INTRODUCTION

1. In accordance with the invitation at paragraph 8 of Minute 11 of the Hearing Panel I comment on the Second Supplementary Landscape Evidence of Tony Milne dated 17 March 2025.
2. This relates to the matter of the effect on the amenity values of the neighbourhood in particular the character of the streetscape, referring to Rule 12.7.7. Reading the Rule in full this is a matter in which Council may exercise its discretion relating to the breach of the BLR. It reflects Policy 6.4.1:

**PHOTOS OF VIEWS FROM IMMEDIATE VICINITY OF STRETCH PROPERTY
36 TERRACE STREET, BANNOCKBURN
SUPPLIED BY JAMES DICEY OF BRDI**

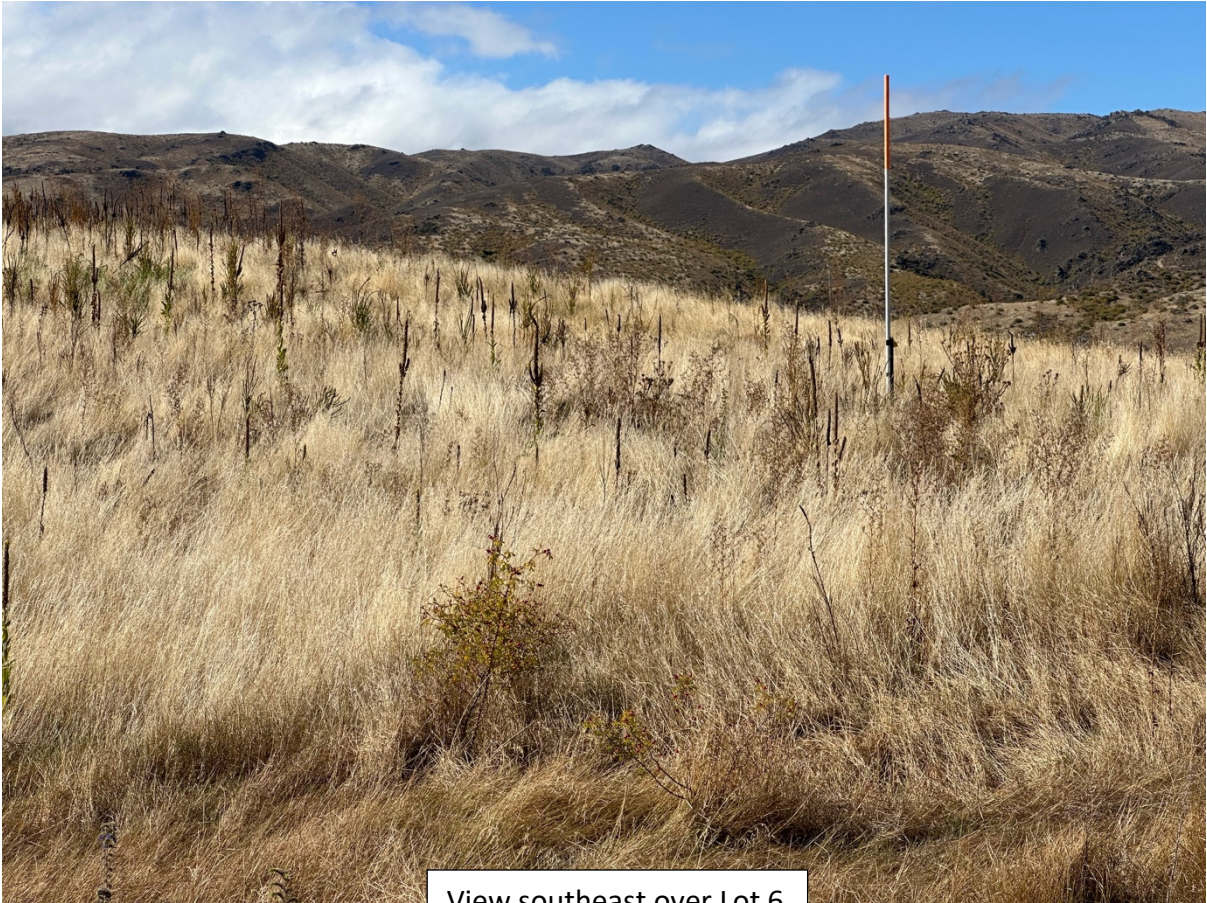
13. Regarding the amenity of the Stretch property at 36 Terrace Street, I have not had an opportunity to visit this property to assess the specific effect on their amenity. I have been supplied with photographs of the view from immediately outside the Stretch property taken by James Dicey (appended). I agree with Mr Milne’s analysis at paragraphs 14 and 15 although he omits the fact that development on Lot 6 would negate views of Lot 6 as open rural landscape itself as well as blocking views of the wider rural landscape. The existing open rural landscape of the relatively elevated Lots 100, 4 and 5 seen beyond the BLR line to the northeast would also be lost to view. Where seen through Lot 2 in the foreground development on Lots 13 and 14 would also be seen on the horizon and skyline in the BLR area transforming and impeding existing open views of near and distant rural landscape. It is accepted that Lot 2 development outside the BLR area has the potential to screen out this view to greater or lesser degree. The Lot 20 poles are visible to the south and development on this lot would intrude into the current views of open rural landscape (both foreground and background).
